MEYLE No.
40-16 010 0004/HD

Ball joint to fit

Citroën Jumper / Fiat Ducato / Peugeot Boxer*

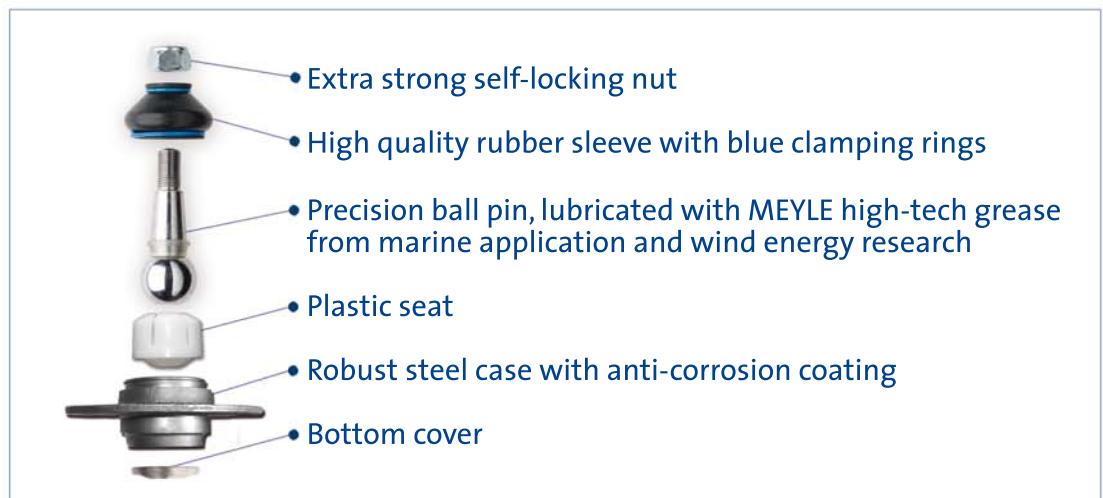
Problem	  Solution
<p>Intense strain of the ball joints due to overloading of the vehicles and fast driving</p>	<ul style="list-style-type: none"> • Less surface pressure due to increased ball diameter (as OE: Ø 30 mm, MEYLE HD: Ø 33 mm) • MEYLE high-tech grease
Effect	Advantage
<ul style="list-style-type: none"> • Worn out ball joints • Noise from the axles • Insufficient driving safety 	<ul style="list-style-type: none"> • Ball joints with long service life
